Access Compliance Report

Public Rights-of-Way

(Curb Ramps)

Intersection ID: 6527	Main Street: FAIRES_FARM_RD	Cross Street: PAMELA_LORRAINE_DR	Location: SE
ADA ID: 362EEF8EE34F	Ramp Type: BlendTrans1	Initial Pass/Fail: Fail	Overall Compliance: No
Codes/Mitigation Info/Possible Solution		Field Measurements/Component Compliance	
Severity Score: 21.25

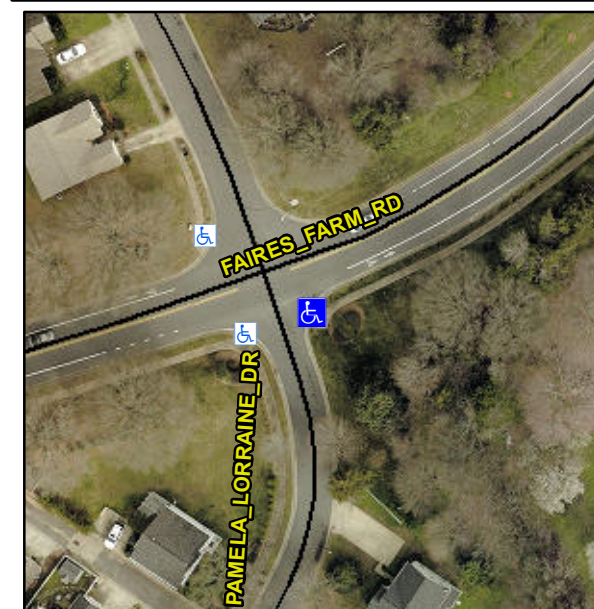
CURB GAP 3.0, NO RT SW

Not Found, R304.5.1, R304.5.3

Remove & Replace Curb Ramp With Two New Directional Ramps or Equivalent.
